Subject: Transmittal Memorandum for Engineering Handbook No. 8, Issuance 71- 10

WIND EQUIPMENT MAINTENANCE NOTE  
(For Electronics Technicians)

11, Consolidation of Supplementary Instructions for Wind Equipment.

EHB-8  
Issuance 72-5

FIG 2

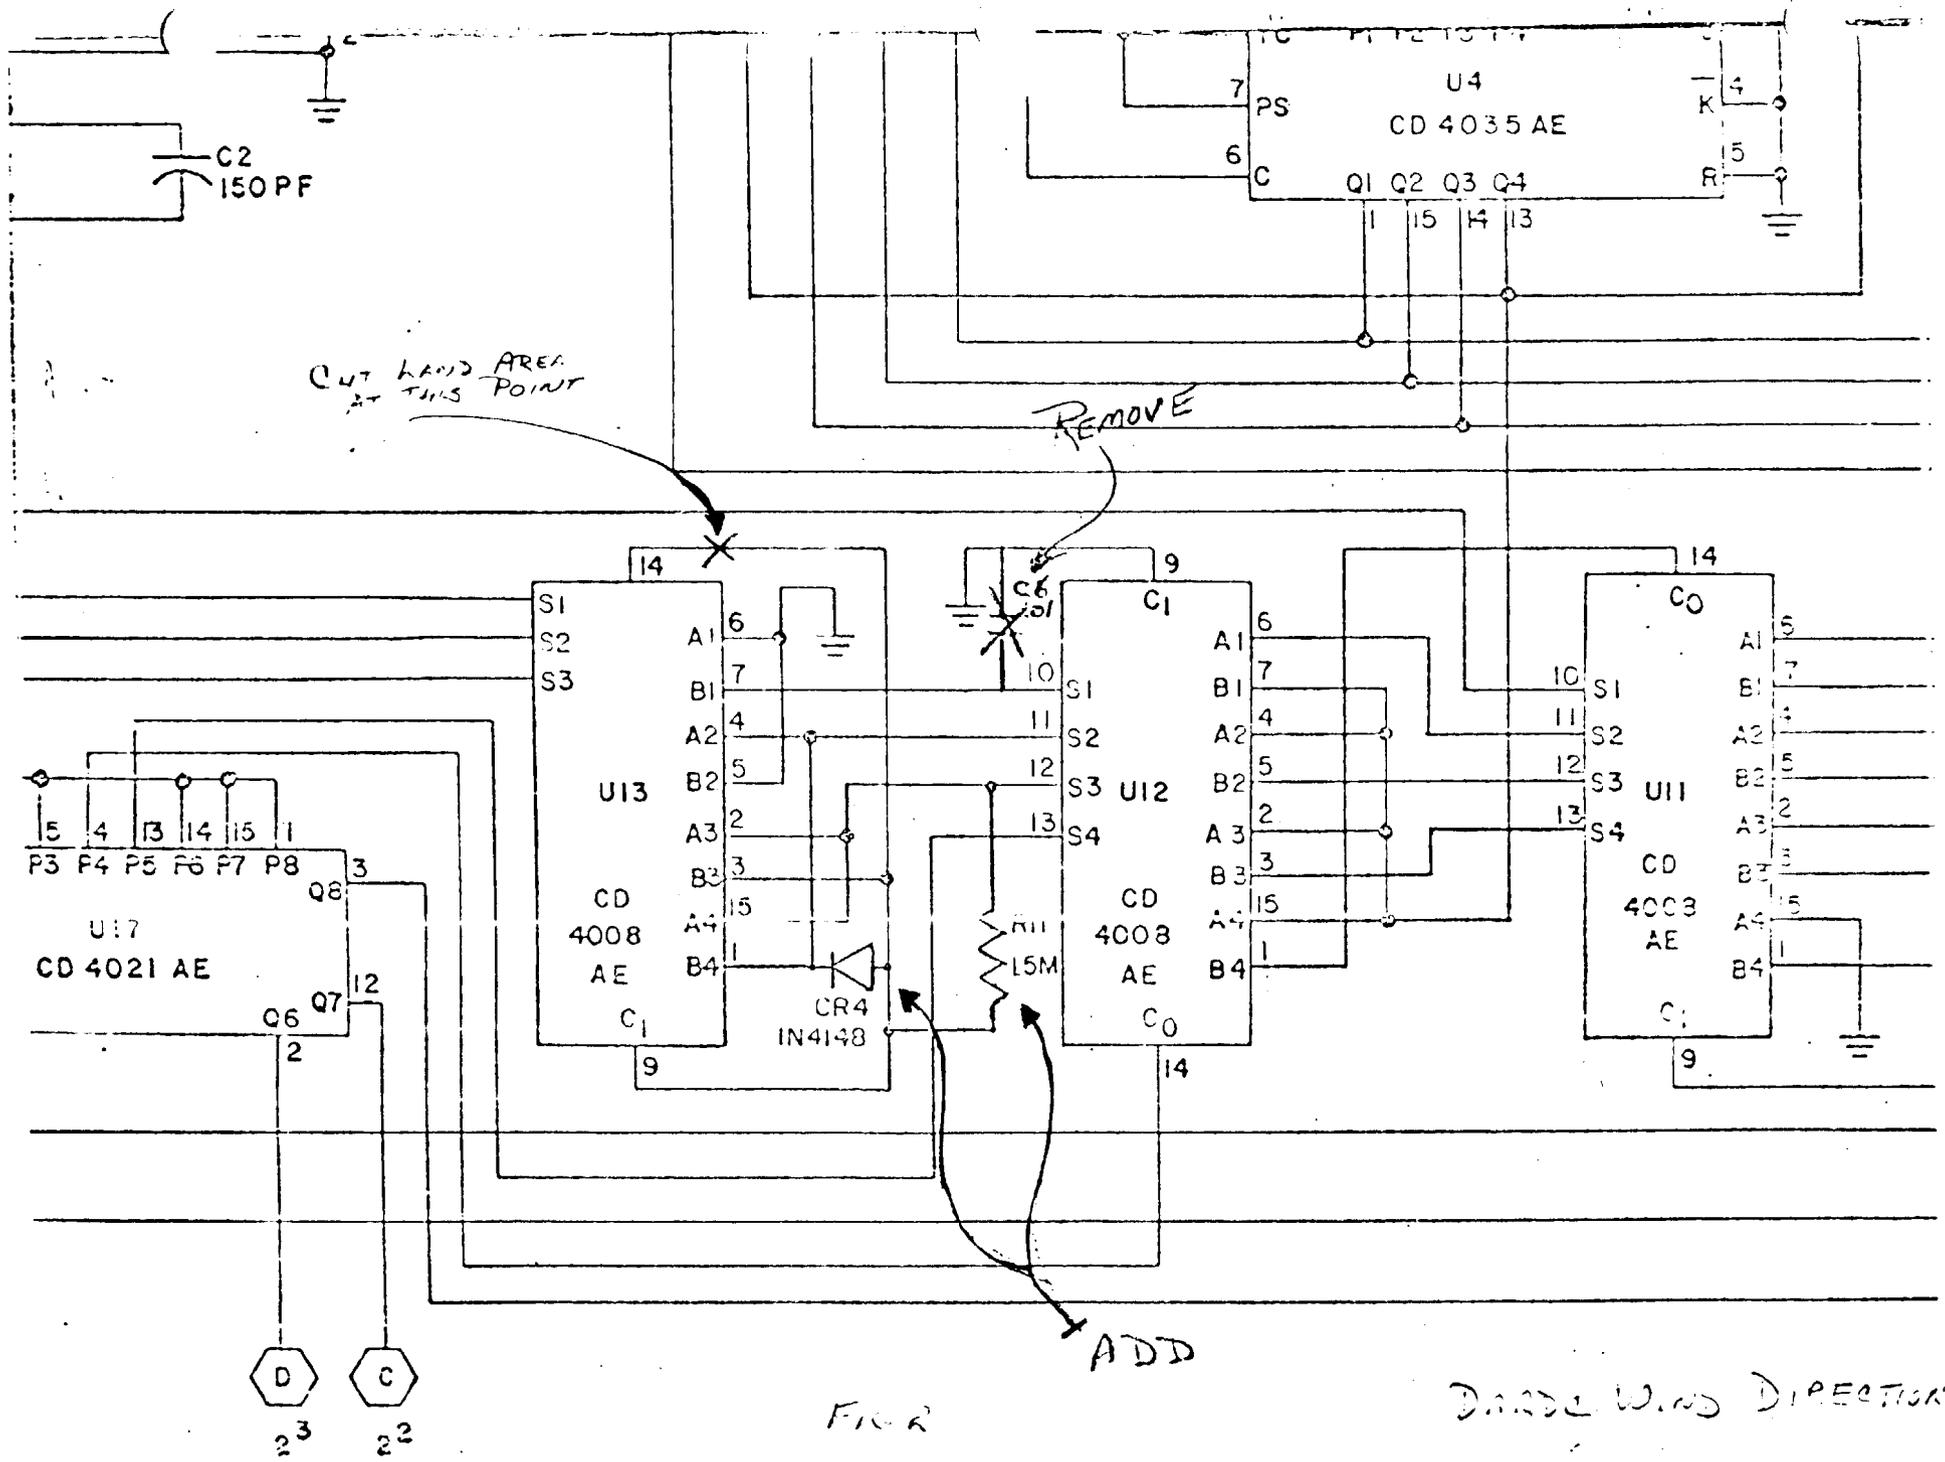
A modification has been devised to correct for this instability problem (refer to attached schematic), and should be noted as follows:

- 1) Capacitor C6 (.01 mf) has been removed.
- 2) Resistor R11(1.5M, 1/4W, 5%) has been added and connected from U12-12 to U13-3.
- 3) Diode CR4 (1N4148) has been added and connected from U13-3 to U13-4.
- 4) Cut land area at U13-14.

**FIGURE 1**

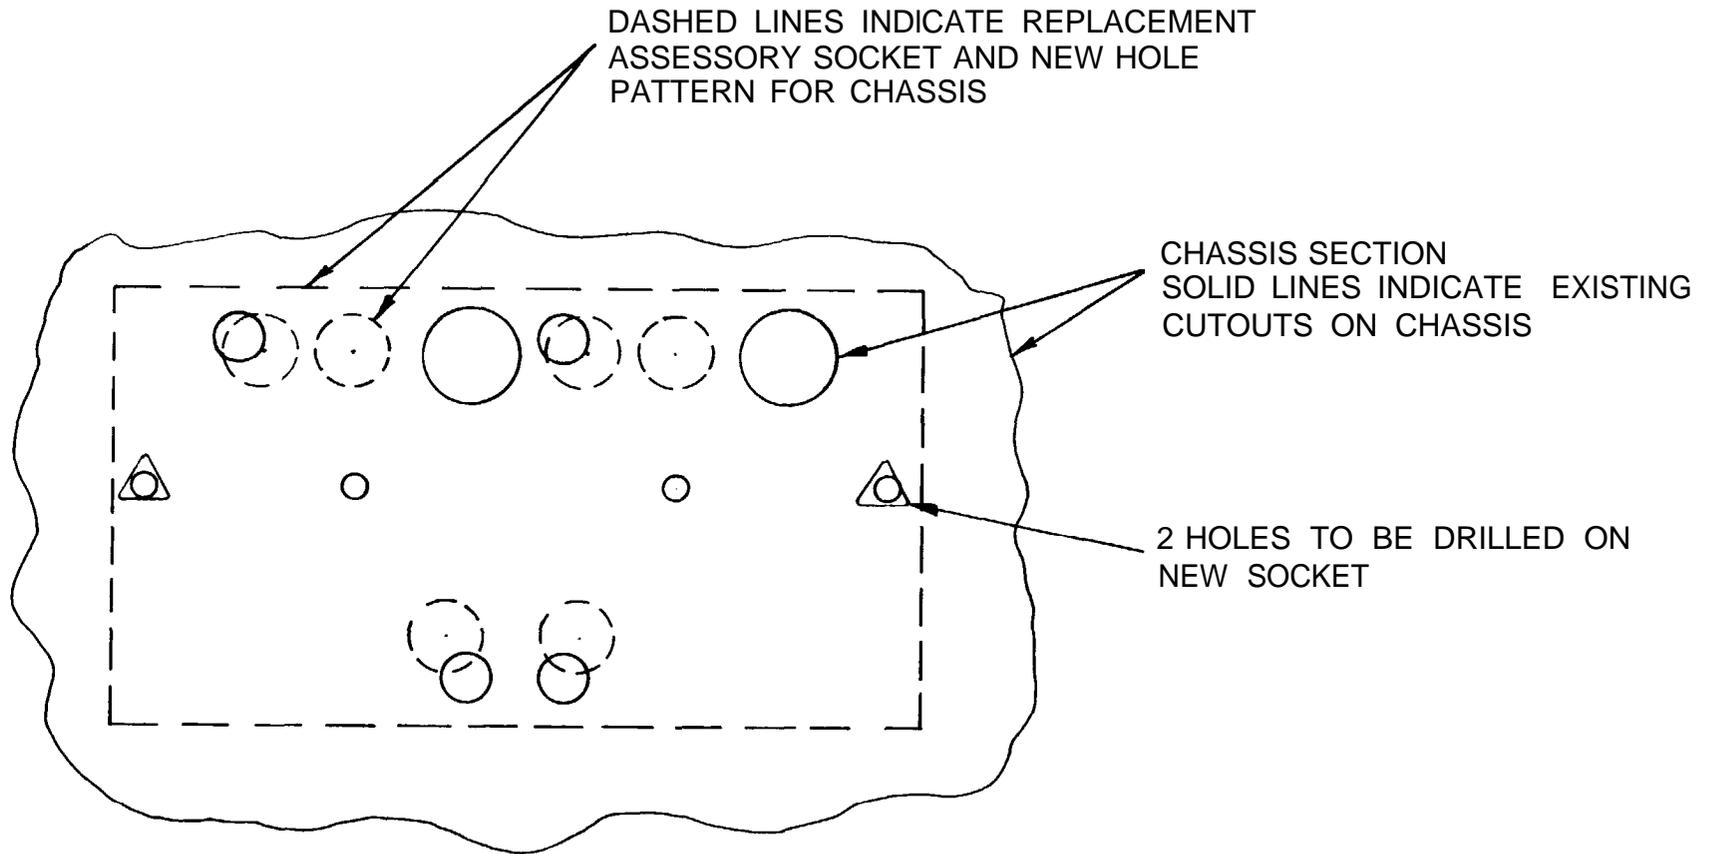
5. Using Figure 1 (attached) as a template, mark new hole pattern on the top side of the F611 chassis,
6. Drill out new hole pattern using 3/8" drill bit. It may be necessary to file or ream the new holes to achieve proper alignment.

FIGURE 2

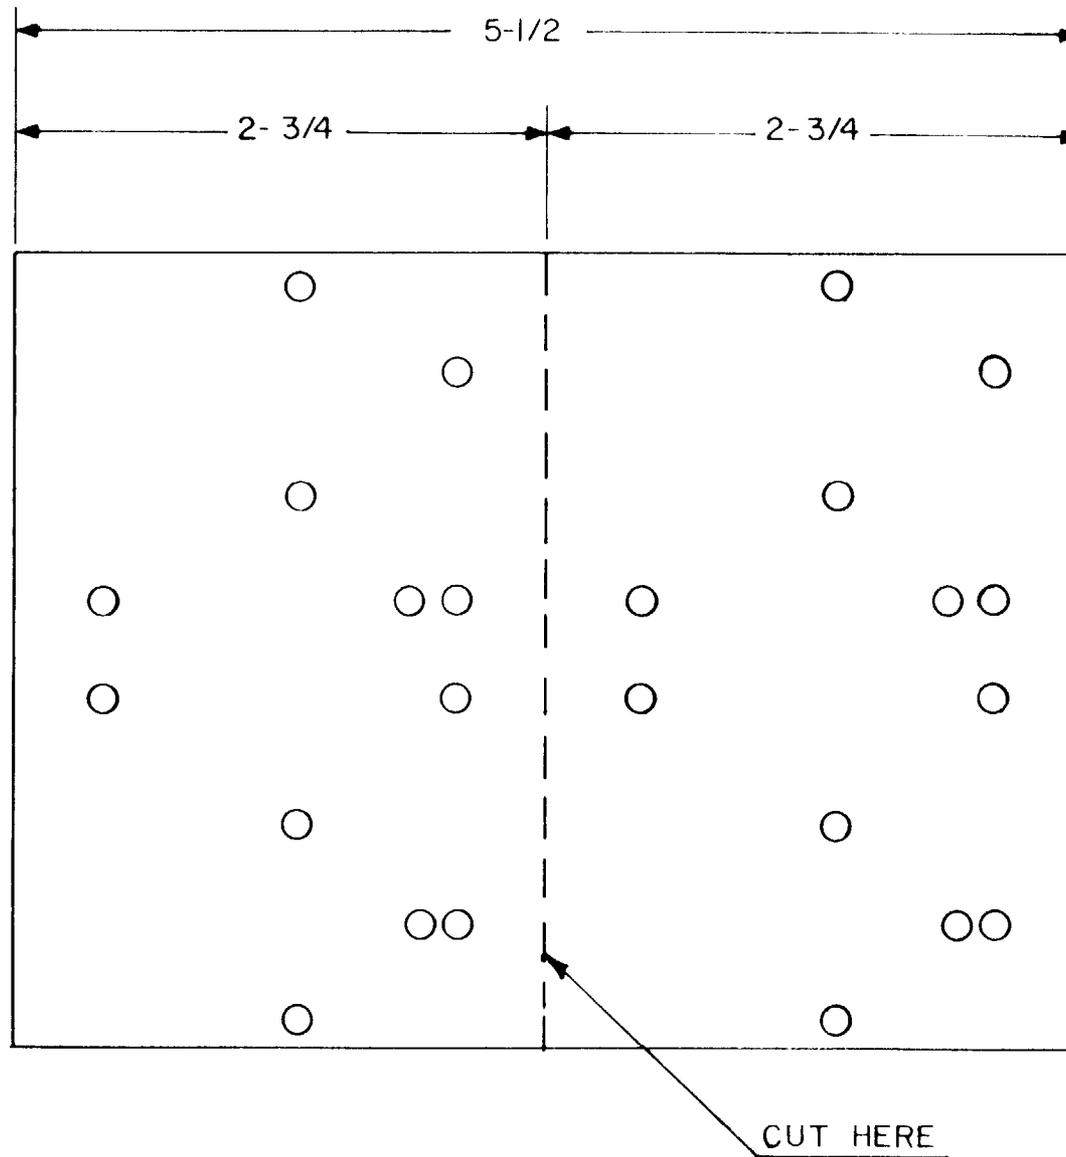
4. Find the center of the existing double power supply connector board (2-3/4" from each edge) and draw a line. Cut the board in half along the center line. (Figure 2.)
